# A G E N D A

## Architectural Review Board

December 15, 2021 – 5:30 p.m.

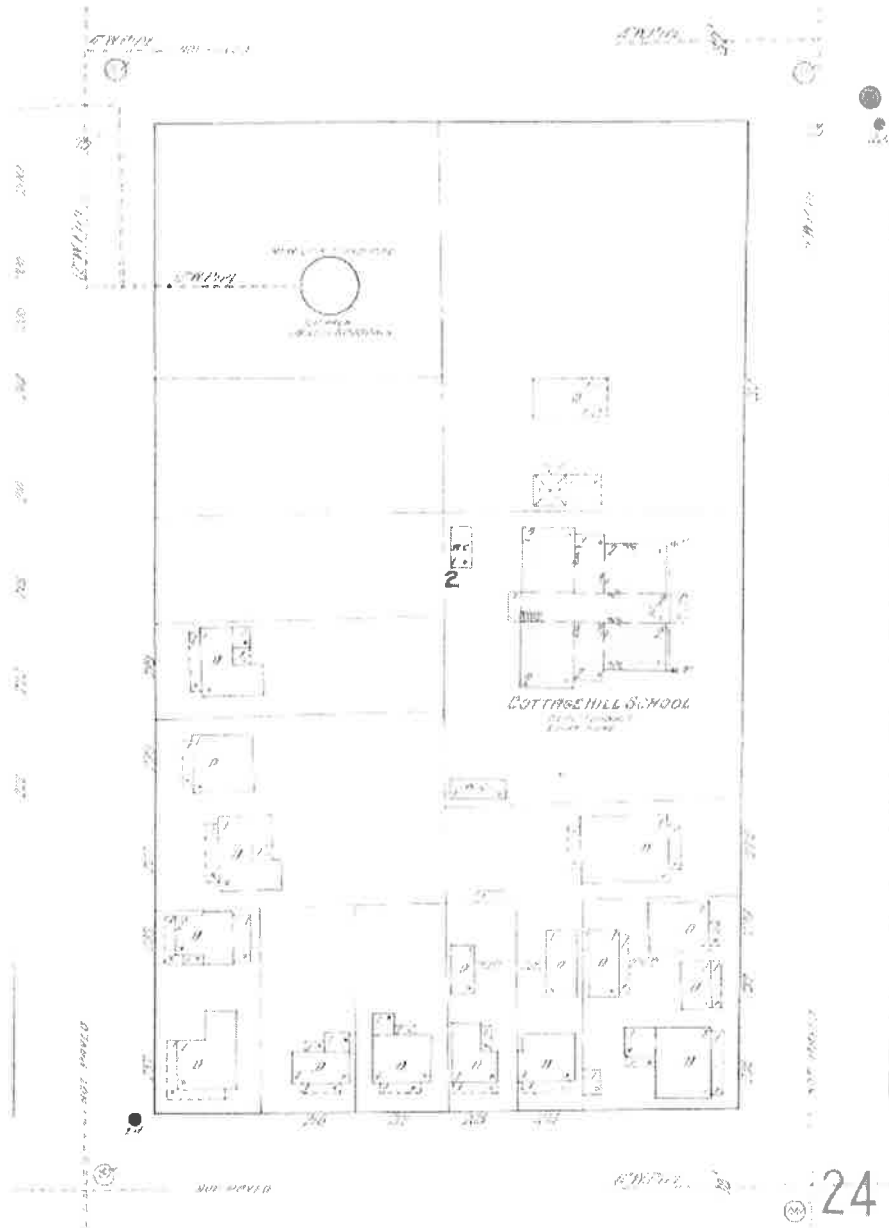
- The extent of the excavation proposed will materially alter the landscape. This block historically had been developed as a residential block with the Cottage Hill School situated on the high point in the block.
- The proposal appears to offer a 1 for 1 replacement for the trees, although some species selection may need to be changed to canopy trees. If ARB approves the project, Urban Forestry recommends approving the tree removal subject to the submission of a final landscape plan for review and approval to address species selection, zoning

- After some additional discussions with Mapco reps, staff suggested that if the proposal did not re-site the building, they needed to start thinking about the property as a “gateway” and how additional design elements might mitigate the appearance of just another gas station. That suggestion is denoted on the site plan as a curved line from Herron Street around the corner to Holt Street, but there is no conceptual plan for what that might look like available at this time.

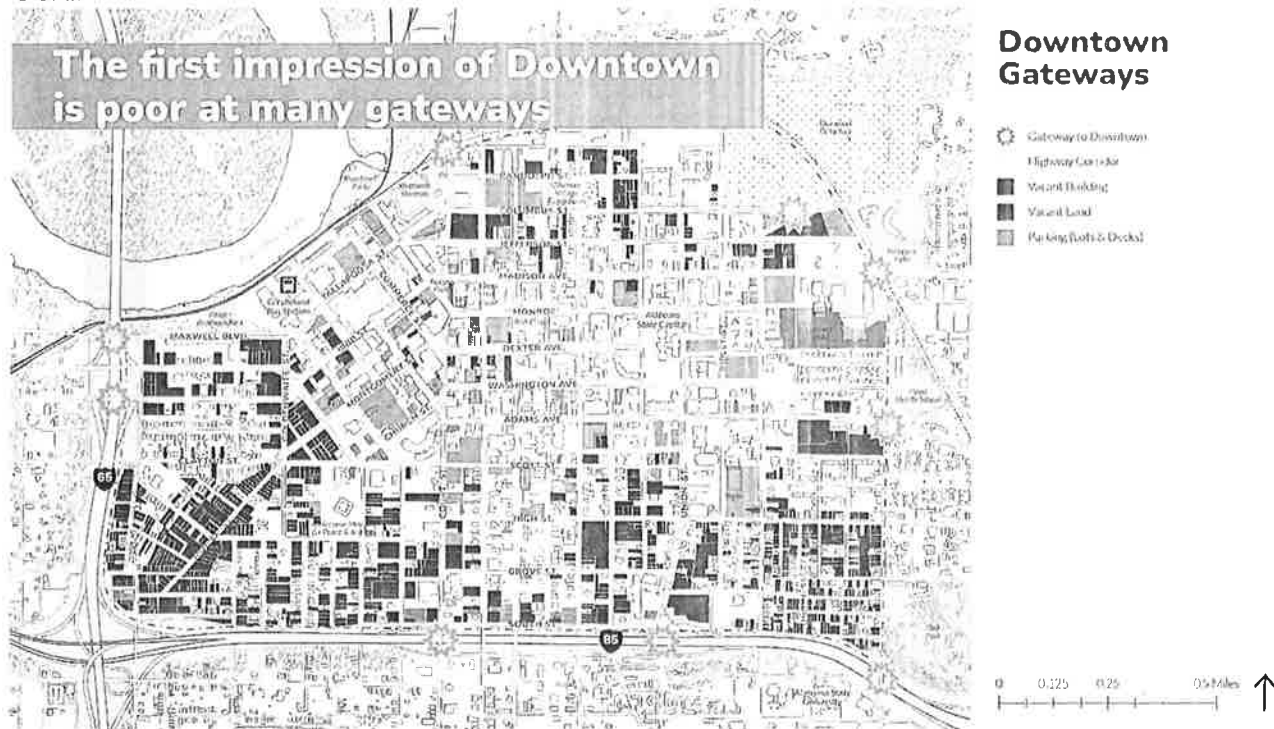
- The Board takes into consideration zoning requirements that may not be fully addressed under the guidelines, particularly with regards to setbacks, landscaping and signage.
- This location at the time the agenda was prepared falls under Smart Code downtown. Smart Code is a form based code, which reinforces historic preservation principles regarding pedestrian friendly, urban form. When the opportunity arises with new construction/development, we need to seek good, pedestrian friendly urban form to help restore a pedestrian oriented urban fabric.

- Does the demolition of historic buildings to build a standard layout gas station at a downtown and historic district gateway “materially impair” the district?
